Technical Bulletin

Bulletin No.: TCH-001-031 Effective Date: 9/1/90

Subject: **BX-2150 Compressor Inlet Check Valve With New & Old Head Assembly**

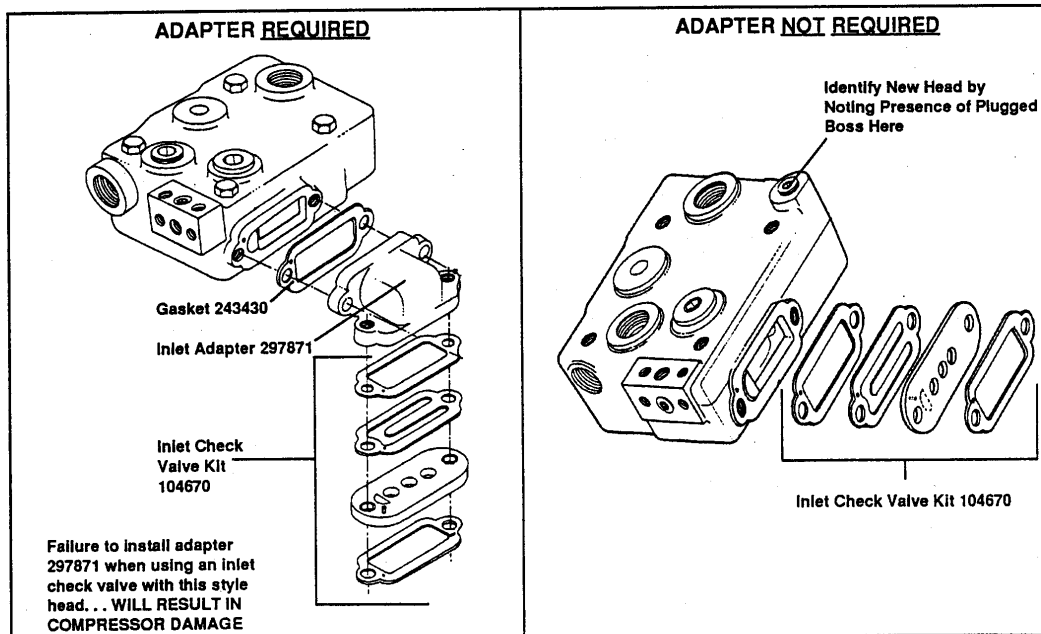
1. Determine that the compressor inlet is NOT CONNECTED TO THE PRESSURE SIDE OF THE TURBO CHARGER. The inlet check valve cannot be used when the compressor is turbocharged.
2. Determine which style cylinder head is installed on the compressor. Bendix recently released a new style cylinder head which is being installed on some new production compressors. The new style head will eventually replace the older head.
3. IT IS EXTREMELY IMPORTANT THAT INLET ADAPTER 297871 BE INSTALLED ON THE OLD STYLE HEAD. FAILURE TO INSTALL THE INLET ADAPTER ON COMPRESSORS EQUIPPED WITH THE OLD STYLE CYLINDER HEAD WILL RESULT IN COMPRESSOR DAMAGE AND EVENTUAL FAILURE. NOTE: Inlet adapter 297871 is not required on the new style head but can be installed in error without harm to the compressor.
